SERVICE BULLETIN

B-097 September 21, 2009

BUELL 2009 XB12Ss SAFETY RECALL 0839

Figure 4. Reflector/Rhino Tape Locations

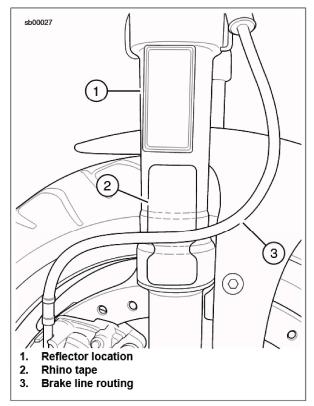
- Remove and discard the reflectors on the outer fork tubes
- See Figure 4. Install the new reflectors (1) pressed up against the lower triple clamp.

- Remove the banjo bolt at the master cylinder/reservoir. Discard the copper washers.
- Remove the banjo bolt at the front brake caliper. Discard the copper crush washers.
- Remove the upper P-clamp from the headlamp module and the lower P-clamp from the fork clamp. Discard the brake line.
- Fit the rhino tape (2) against the lower edge of the outer fork tube and press into place.
- Route the new brake line (3) behind the headlamp module and around the outside of the front fork along side the rhino tape.
- Install both banjo bolts with new copper crush washers.
 Tighten to 16-20 ft-lbs (22-27 Nm).
- Install the upper P-clamp to the headlamp module and tighten to 36-60 in-lbs (4-7 Nm).
- See Figure 5. Install the front brake line guide and tighten to 36-60 in-lbs (4-7 Nm). Fill and bleed the front brake. See the service manual.
